FINAL TECHNICAL MEMORANDUM

TO: Dan Heilig, Wyoming Outdoor Council and
Jill Morrison, Powder River Basin Resource Council
FROM: Jean Marie Boyer, PhD, PE, Hydros Consulting Inc.
SUBJECT: Review of ERM Water-Quality Modeling Study of Boysen Reservoir
DATE: July 1, 2019

Figure 2. Wind Speed Figure from the ERM Report. Red line added at 5 m/s (9.7 knots)

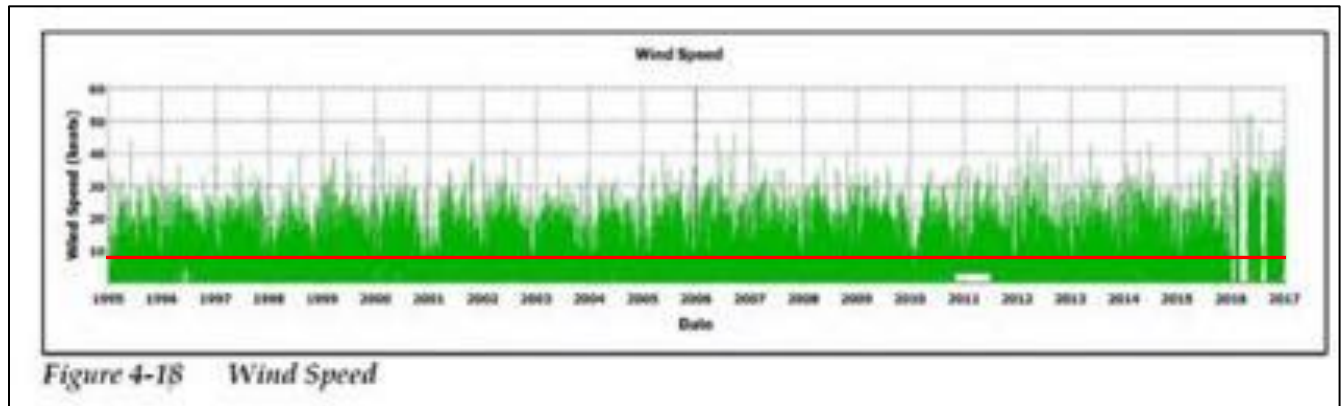
5. Wind Speeds Were Significantly and Unrealistically Capped

The Wind River basin experiences high wind conditions, as displayed in Figure 2 where wind speed is reported in knots. The model as delivered to Hydros by ERM is set up to “cap” wind speeds to a maximum of 5 m/s (9.7 knots) during the simulation, as indicated by the model setting in Figure 1 above.

Artificially reducing the wind speed serves to reduce mixing and increase stratification (something the model has troubles simulating). It appears that the modeler used this cap to make up for other important model development problems. This significant adjustment was not described anywhere in the Report and the reader is led to believe that the values shown in Figure 2 were used.

Figure 3. Assumed Iron Concentrations at the Wind River Above Boysen Reservoir (from Report)

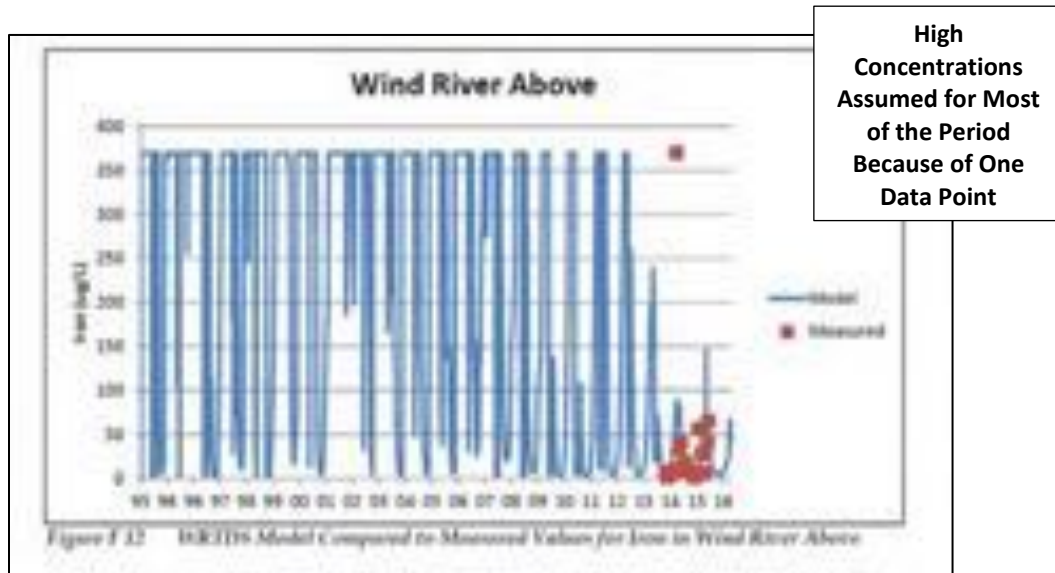
7. Questionable Use of Method for Quantifying Inflow Concentrations

For some constituents, ERM used the WRTDS (Weighted Regressions on Time, Discharge, and Season) method to describe inflow concentrations for Wind River above the reservoir, 5-Mile Creek, and Muddy Creek (see Appendix F of the Report). The results from using this methodology are questionable and unrealistic in some cases. ERM subjectively capped what was determined to be excessively high concentrations. In addition, odd results sometimes occurred due to extreme values in a single or few data points and certain trends were created that are not described or justified. Examples are shown in Figures 3 and 4. Note that Wind River provides the majority of the inflow into the reservoir (over 70% according to Appendix C of the Report) and its water quality is an important driver of in-reservoir dynamics.

Figure 7: Temperature Calibration Figure for Outflow (from Report)

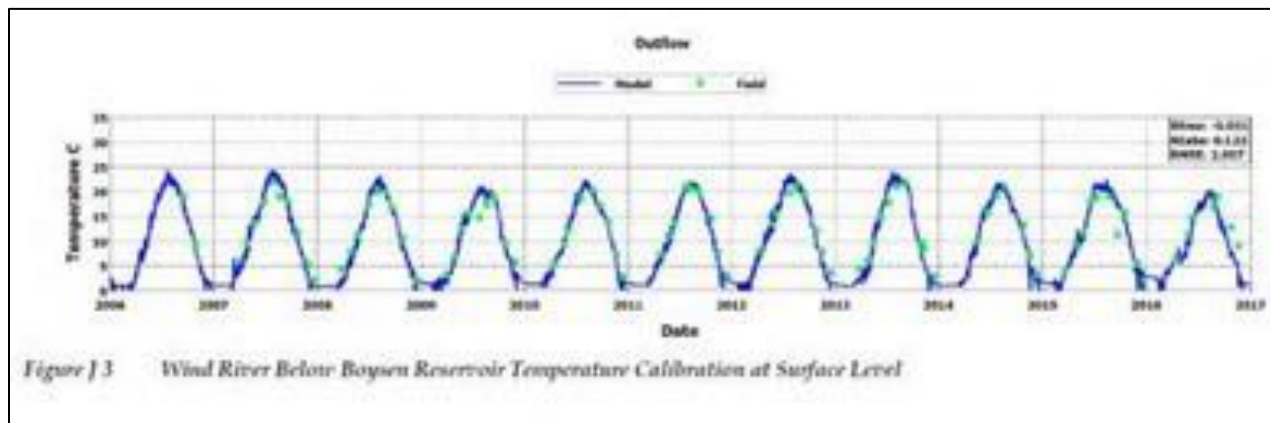
12. Evaluation and Reporting of Wind River Results are Wrong and Misleading

Through review of the model files, our team determined that the graphs displaying calibration and validation results for the Wind River below the reservoir are misleading and severely flawed. An example graph for temperature is shown in Figure 7. The top of the graph is labeled as “Outflow” and the caption says “Wind River Below Boysen Reservoir.” The data (green markers) are reportedly Aethon’s temperature measurements in the Wind River below the dam. The reader is led to believe that the blue line represents the temperature of the water released from the reservoir (via the low-level outlet and/or the spillway) and delivered to the river.

According to the model files, the blue line actually represents the simulated temperature at the top model layer (~top 2 feet) of the most downstream location (at the dam). This is wrong and misleading and it is unclear why this was done. Note that ERM added “at Surface Level” at the end of the caption (Figure 7) and perhaps thinking this makes it not misleading, even though there is a low-level outlet used for power production?

This is a very serious problem since the water quality at the top two feet of the reservoir is being represented as Wind River water quality and there are observed (but not simulated) vertical variations in the reservoir. In reality, the water quality at the top of the reservoir is often different from the bottom of the reservoir⁵ (see Figure 6). Since water is removed predominantly through the low-level

Figure 11. ERM's Figure Showing Observed and Simulated Temperature Profiles

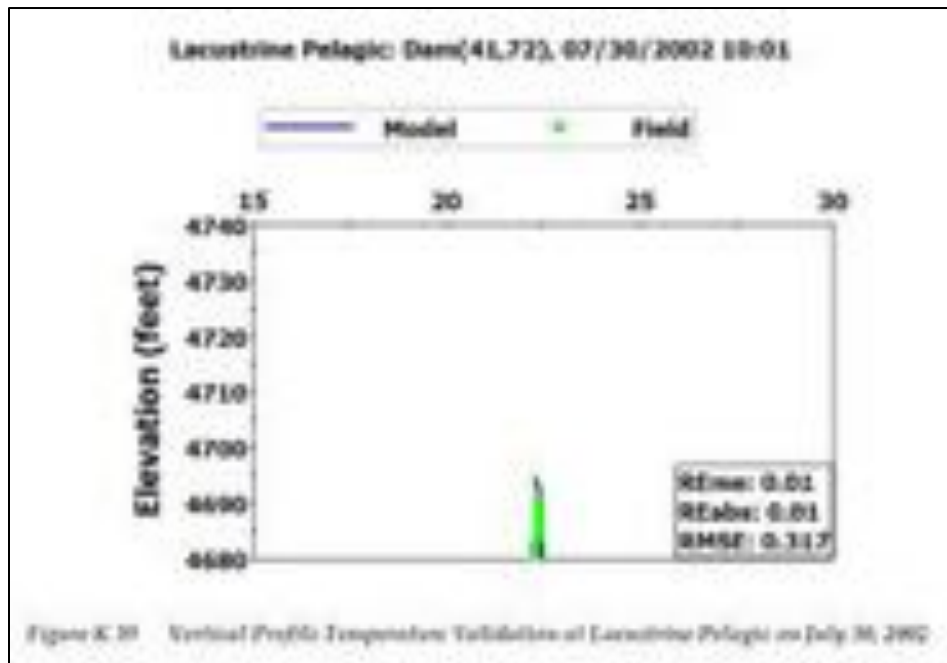
15. Information Was Concealed by Limiting Bottom Elevations Displayed on Profile Graphs

In-reservoir observed and simulated results are shown in the Report in Appendices J and K for temperature, TDS, and pH with depth. All of the graphs provide data and results for elevations above 4,680 feet. This elevation is not at the bottom of the reservoir (at least near the dam) and cutting off the elevations in the figures leads the reader to assume that the reservoir is typically well-mixed summer and does not stratify or have much vertical variation. In addition, the model results show something similar. An example is shown in ERM’s Figure K 39 (Figure 11) for July 30, 2002 near the dam, where the reservoir appears to be well-mixed with good model predictions (and hot from top to bottom).

Figure 15: Chloride Observations in the Wind River below Boysen Reservoir (2010-2016)

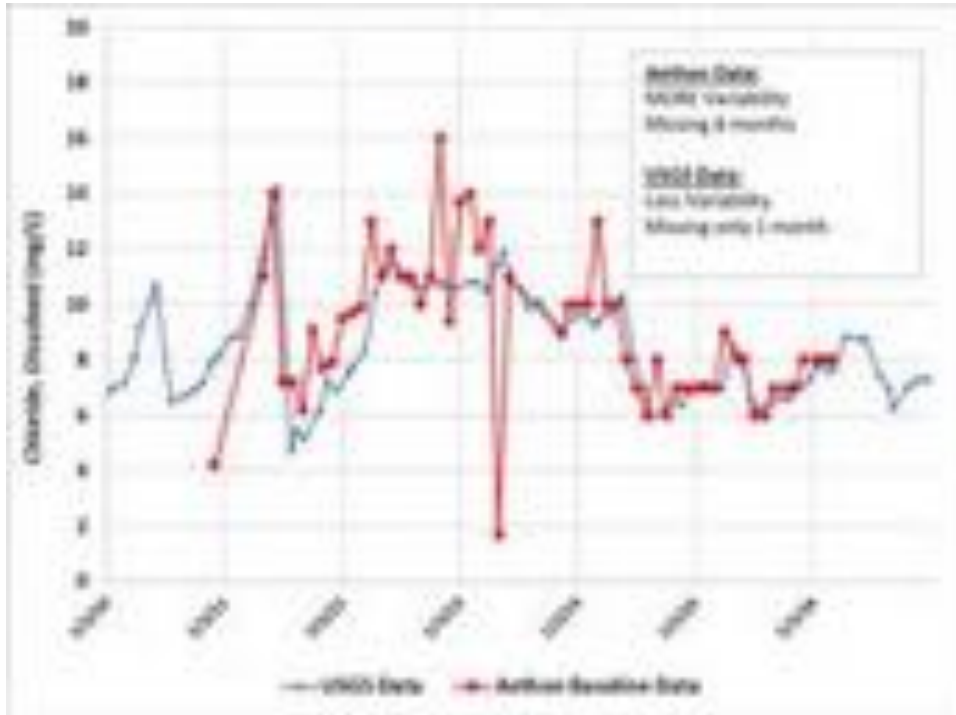
18. ERM Failed to Use USGS Data for Defining Baseline in Class I Segment

Only Encana/Aethon-collected data were considered when defining baseline conditions for the Class I segment of the Wind River. Yet, there are hundreds of approved water-quality measurements from the USGS below the reservoir for the period ERM defined as baseline (December 2010 – March 2016). Approved USGS data are considered to be of very high quality. In some instances, there are more data from the USGS in this period (Encana/Aethon did not report data for 8 months of the baseline period; Figure 15). In addition, there is much more variability in much of the data collected by Encana/Aethon than the USGS (see Figure 15 as an example). This variability would serve to increase a standard deviation.

Baseline conditions should be defined using USGS data which is of higher quality and more complete, in most cases.

Figure 16: Chloride Measurements, Wind River Below Boysen Reservoir, Aethon Data. Individual Measurements (Left); Lumped Average Monthly Values (Right); Illustration of Reduction in Variability.

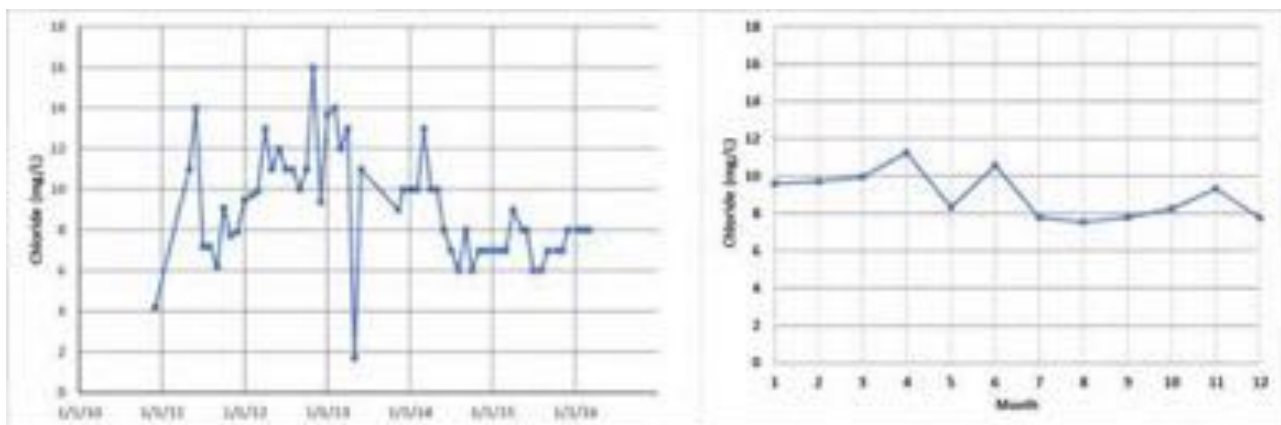
19. Used Monthly Averages, Obscuring Results

ERM chose to complete the compliance analysis on an average monthly basis. So, all Januarys are averaged together, Februarys are averaged together etc. This method lumps the data, reduces observed variability, and also serves to hide important differences that occur year-to-year, especially since time-series of the results are not displayed. This point is illustrated for chloride in Figure 16.

For the example above (Figure 16), the SD for the un-lumped data (left) is 2.7 mg/L, while the SD for the lumped data (right) is 1.2 mg/L. This makes a considerable difference in the antidegradation analysis, since the larger SD allows for larger decreases in water quality (Figure 20).

Figure 17. Model Output for “Outflow” (Top 2 ft of the Reservoir); Model Calibration and Case 01

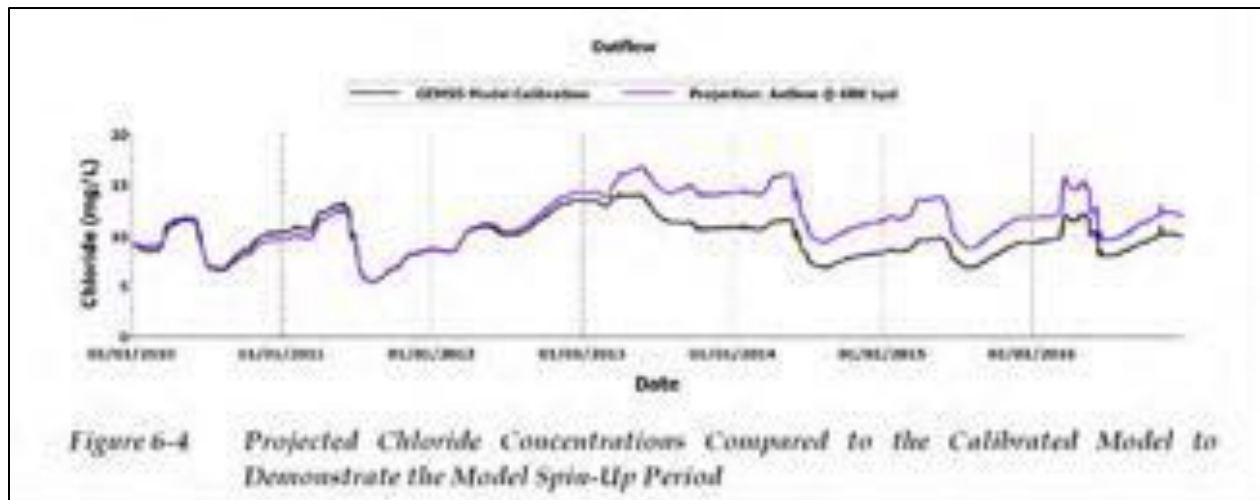
ERM did display chloride results in an attempt to justify the model “spin-up” period and to only focus on model results from December 2010 – March 2016 (Figure 17). Note that the project results in lower chloride concentrations in the “outflow” (top 2 feet of the reservoir) in 2010-2011.

Because the projection flows (68,000 bpd; Case 01) are lower than what actually occurred in 2010 and 2011, the model shows an improvement (lower concentrations) with the project. Starting in 2013, when the projection flows are much higher than the actual, the model shows some significant increases in concentrations (Figure 17).

Figure 19. ERM Figure Showing Impact of the Project for Case 01

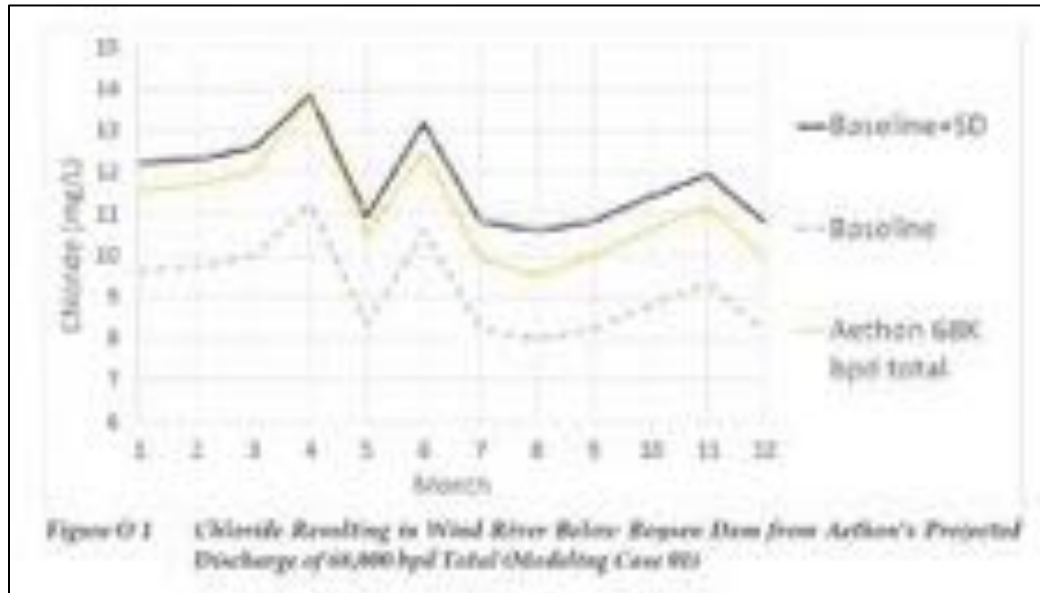
The analysis should be presented on a daily basis so that periods of larger impact are transparent. For example, from Figure O 1 (Figure 19), the reader could assume that April concentrations may only increase by up to 2.7 mg/L chloride, while the time-series data (Figure 17) show increases of up to 4.6 mg/L at times.

Figure 21. ERM Results for the Compliance Analysis for Dissolved Nickel (Red Line and Two Text Boxes Added)

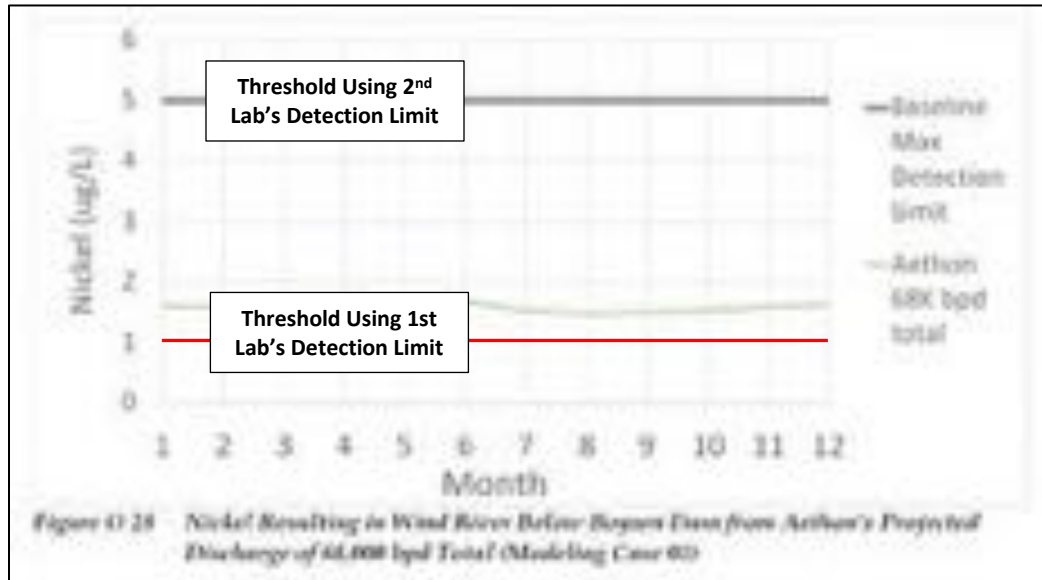
As an example, more detail is provided here for dissolved nickel. For the Aethon sampled Wind River data (which was exclusively used to determine baseline versus using USGS data), the detection limit was 0.5 ug/L from December 2010 through June 2013. Then a different lab was used for November 2013 – March 2016⁷ and reported a 5 ug/L detection limit. It is not clear why the detection limit would

Using the approach developed by ERM, the results are displayed as Figure O 28 in Appendix O (see Figure 21). Using the threshold of 5 ug/L (based on the 2nd lab's detection limit), it appears that the project will not result in degradation in the Class I section. However, if the lab change had not occurred (or if the minimum DL was chosen), then the conclusion would be that degradation would occur.

Overall, this method and its implementation are flawed.
